Resolution 2019-12

**RESOLUTION OF THE CITY COUNCIL REGARDING THE GRANTING
OF A VARIATION TO THE SUBDIVISION ORDINANCE**

HAMPTON GLEN – PHASE 4
CITY OF TROY, ILLINOIS

Fact Sheet for the Public Hearing
Oates Associates, Inc.
JUNE 13, 2019

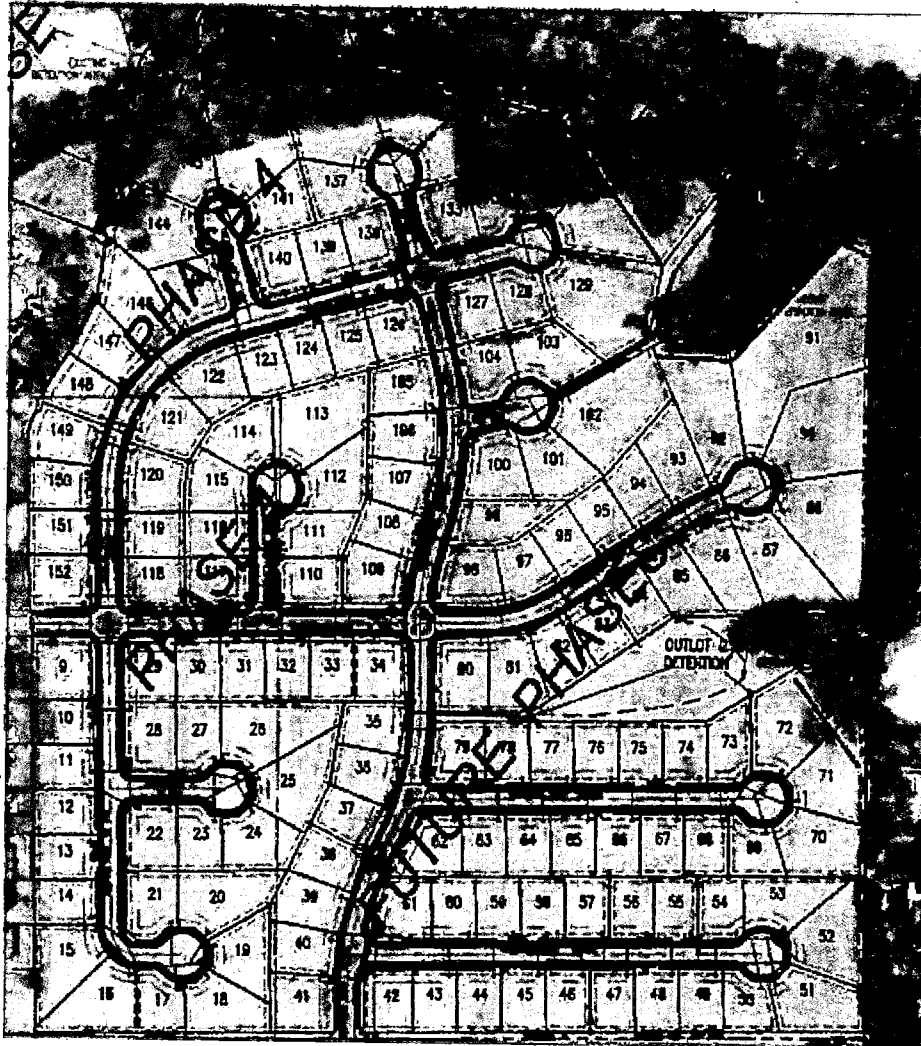
There was a preliminary plat submitted and approved in 2006. Since then, we revised the Subdivision Ordinance last year to include a green space requirement. The current requirement for a R-1 development is that 10% of the total area shall be green space. The original design for Phase 4 – and the already constructed Phase 1, 2, and 3 – does not contain greenspace.

Therefore, in the City Engineer's opinion, the developer is asking for a variance to provide some greenspace, but not the entire amount that is currently required. They are meeting us a little over half-way to our current requirements by providing about 6%.

- (1) The reason presented basically states that our lots have more "greenspace" incorporated in them that required in surrounding communities.
- (2) The developer also has provided a 3.71 acre right of way dedication for Country Lane – allowing future road improvements.

- (3) The development as proposed matches the character of Hampton Glen – Phase 1, 2, and 3.
- (4) According to Section 153.086, Greenspace requirements can be reduced by up to 30% by using some of the following methods that are incorporated into the design. Are they/ can they do any of these for up to a 25% credit?

- (5) We could request conservation easements as outlined in red and if they were incorporated, there would be a 25% credit to the greenspace requirement in the Code after considering 4c, 4d, and 4e. This seems like a good way to keep the layout/ lot sizes the same and justify the green space reduction.

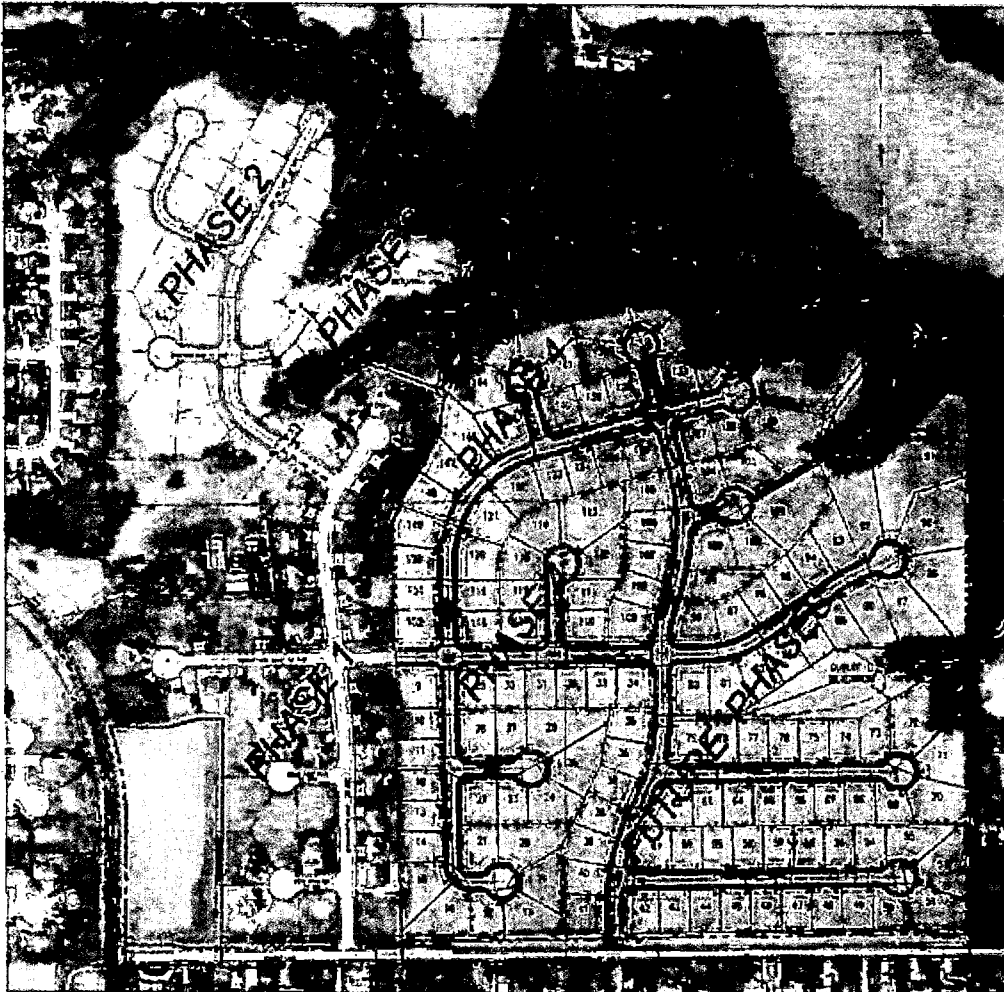
There was a preliminary plat submitted and approved in 2006. Since then, we revised the Subdivision Ordinance last year to include new street design standards. The current requirement for a residential street is 8" of concrete on 4" of rock and 12" of stabilized subgrade.

The developer is asking for a variance to provide 7" of concrete on 12" of stabilized subgrade on the lower traffic streets. This matches the requirement when the development was started.

- (1) The reason we increased the street design standards was because streets built in the 90s and 2000s needed major repairs/ patching throughout the City.
- (2) Phase 1 was constructed with asphalt. Phase 2 and 3 were constructed using 7" of concrete. Are any of these streets failing? Are they holding up well?
- (3) The development has taken longer than anticipated.
- (4) The PC is currently considering smaller lots and reduced setbacks.
- (5) As a minimum requirement, the major streets will remain 8" of concrete and 4" of rock on 12" of stabilized base as requested by the City. The streets that will remain thicker are highlighted:

Grant the variation to the Subdivision Code with the following stipulation:
Pavement to consist of 7" of concrete and 4" of rock on 12" on stabilized subgrade on Montauk Road, Cryder Lane, Suffolk Court, Herrick Park Drive east of Waterford Drive, Maidstone Court, Stonington Court, Mulford Way and Waterford Drive north of Guilford Place; Guilford Place from Herrick Park Drive to Waterford Drive will consist of 8" of concrete and 4" of rock on 12" of stabilized subgrade.
